SOUTH DAKOTA WATER WELL COMPLETION REPORT

From: Fagnan, Brian
Sent: Wednesday, April 24, 2024 10:34 AM
To: Kilts, Whitney (DENR); Noyes, Joanne
Cc: Mathiowetz, Adam (DENR)
Subject: RE: Sturgis area geology question

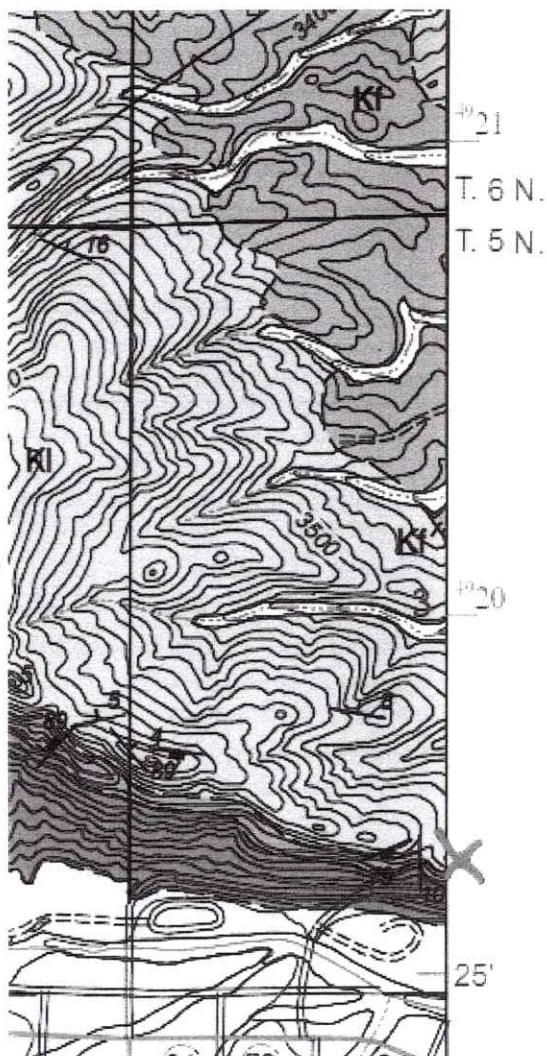
Based on the geo map below (red mark for well location) and the thicknesses from the map explanation, I would agree with your assumptions. I would say the depth of the well reaches the "top" of the lower quarter of the Sundance Formation, or roughly 300' into the Sundance Formation. However without a geologic map for this specific location, this is just an estimate.
